## **LYLE MACHINERY CO. SUBDIVISION**

APPLICATION NUMBER 3 DATE June 16, 2022

REQUEST Subdivision

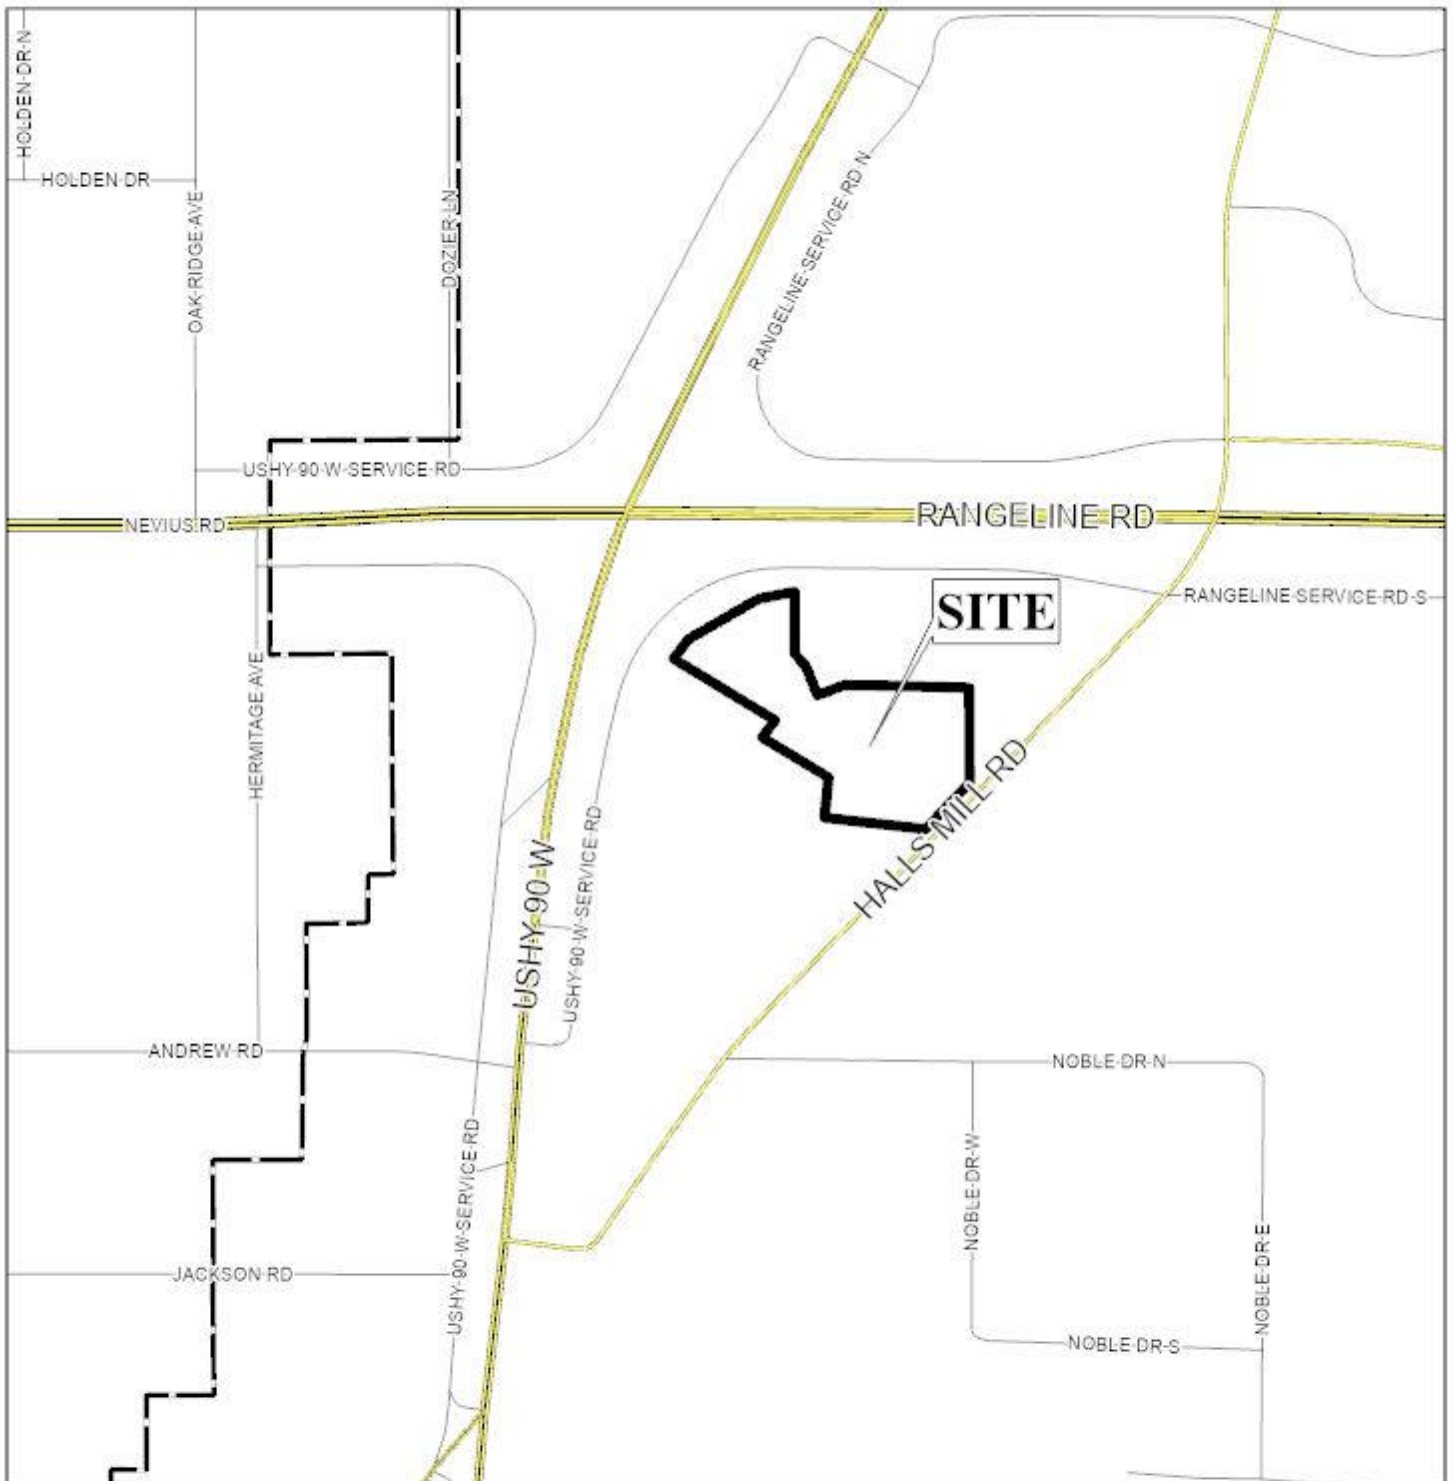
The site has frontage on Halls Mill Road, a minor arterial road included in the Major Street Plan, with a required 70-foot right-of-way at this location. The site has additional frontage on Rangeline Service Road South, a marginal access street with a required 40-foot right-of-way. The preliminary plat lists both street's rights-of-way as "varies", and as such, should be revised on the Final Plat to illustrate compliant right-of-way widths labeling each width from the center line. It is important to note that should compliant right-of-way widths not be possible as proposed, dedication will be required and should be illustrated on the Final Plat.

The plat indicates a 25-foot minimum building setback line along Halls Mill Road which should be retained on the Final Plat, adjusted for dedication if approved. No minimum building setback is shown along Rangeline Service Road South. As such, if approved, the Final Plat should be revised to include a compliant setback along both frontages, adjusting for dedication as needed. The proposed lot meets the minimum size requirements of the Subdivision Regulations. As on the preliminary plat, the lot size label in both square feet and acres should be retained on the Final Plat, or a table should be furnished on the Final Plat providing the same information, adjusted for dedication, if approved.

It should also be noted that the neither the preliminary plat nor the site plan submitted to staff illustrates a sidewalk along either Halls Mill Road or Rangeline Service Road South. Sidewalks are required along the street frontages of all new developments and redevelopments within the city, per the Subdivision Regulations, and as required by the City's Complete Streets Policy adopted by City Council in 2011. As such, a sidewalk should be constructed along Halls Mill Road and Rangeline Service Road South at the time of development; or, the applicant may request Sidewalk Waiver Approval from the Planning Commission to waive this requirement.
